133 14TH AVENUE

DESIGN REVIEW

DPD #3012729

SEPTEMBER 19TH, 2012

D-7 PERSONAL SAFETY AND SECURITY

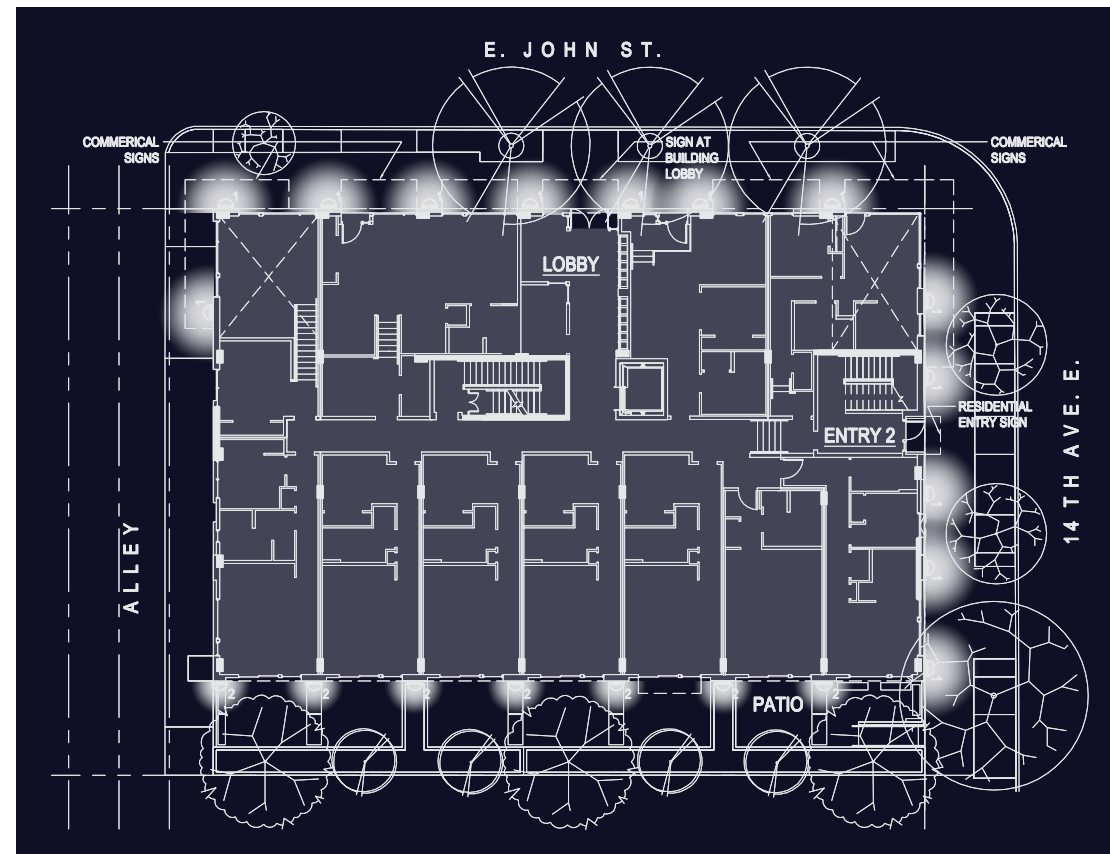
EDG Board Commentary: The Board noted that exterior lighting, clear sight lines and transparency at ground level should be considered for enhancing site and pedestrian safety and should be presented at the next meeting.

Response: A lighting plan and selected fixtures are part of the submittal. Lighting will provide security and personal security at all streets and the alley. Extensive clear glazed windows will provide security and “eyes on the street” where appropriate.

E-1 LANDSCAPING TO ENHANCE THE BUILDING AND/OR SITE

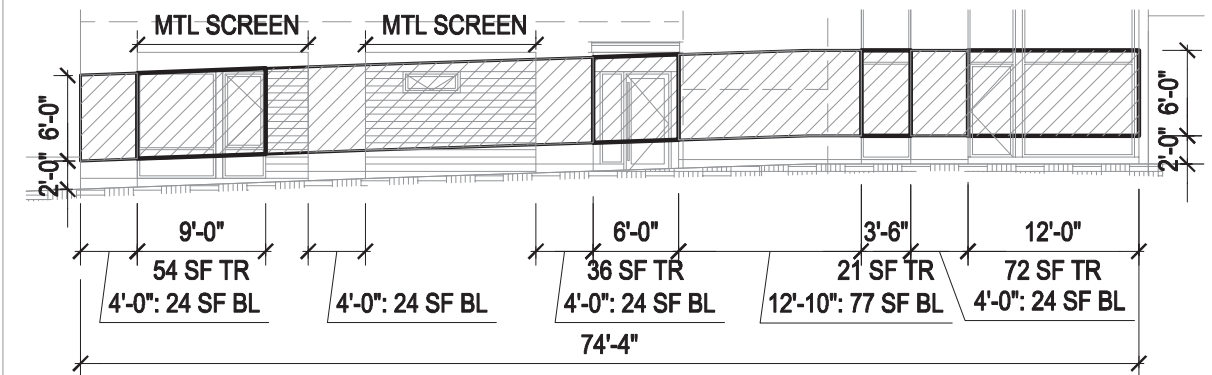
EDG Board Commentary: The Board expressed a strong interest in the development of the ground level streetscape and right-of-way that includes a visually interesting and street-activating environment with landscape and hardscape features.

Response: A visually interesting and street-activating environment will be achieved through the use of a diverse plant palette with varied foliage colors, textures, and seasonal changes. The existing sidewalk on E. John is proposed to be widened. The existing brick paving will be removed from the planter strips on both streets and replaced with shrubs and ground covers. Stormwater planters, proposed along the south edge of the property, will be visible from the street. These stormwater planters will also include planting with interesting foliage colors, textures, fall colors, and winter interest with brightly colored branches on deciduous shrubs. Two varieties of trees, one taller and columnar and one shorter and broader, have been added to the stormwater planters to provide a rhythm of foliage across the façade and provide visual screening between the unit terraces and the building to the south. In addition, the alley on the west side of the building will be widened and will be partially paved with pervious concrete and planted with two shallow bioswales along the building's base. The shallow bioswales will be planted with colorful evergreen grasses and low shrubs, and will each contain a columnar tree.

RESIDENTIAL STREET-LEVEL USES SMC 23.47A.005.C.4.D

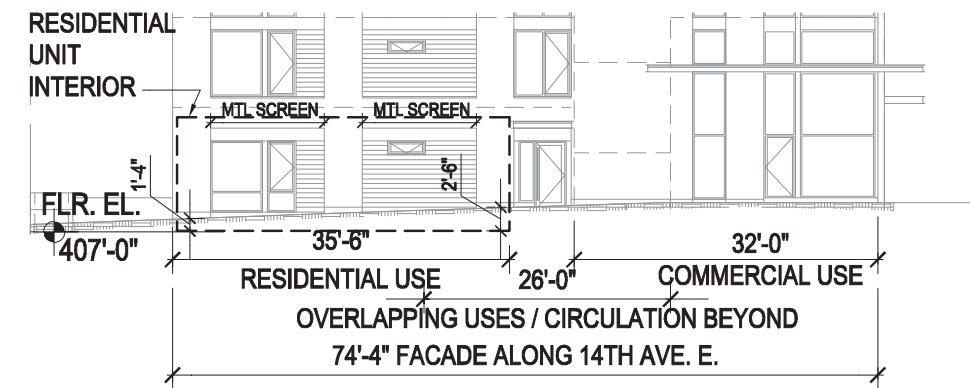
FLOOR LEVEL DEPARTURE REQUESTED
 UNIT FLOOR AVERAGE BELOW FINISHED
 GRADE IS APPROXIMATELY 2' (VARIES
 BETWEEN 1'-4" AND 2'-6")

STREET-LEVEL DEVELOPMENT STANDARDS SMC 23.47A.008.B.3.b

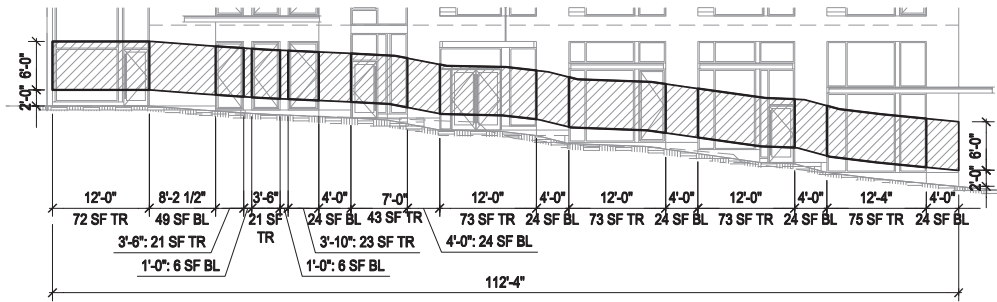
FUTURE BACK-OF-SPACE TI MEZZANINES MAY REQUIRE DEPARTURE
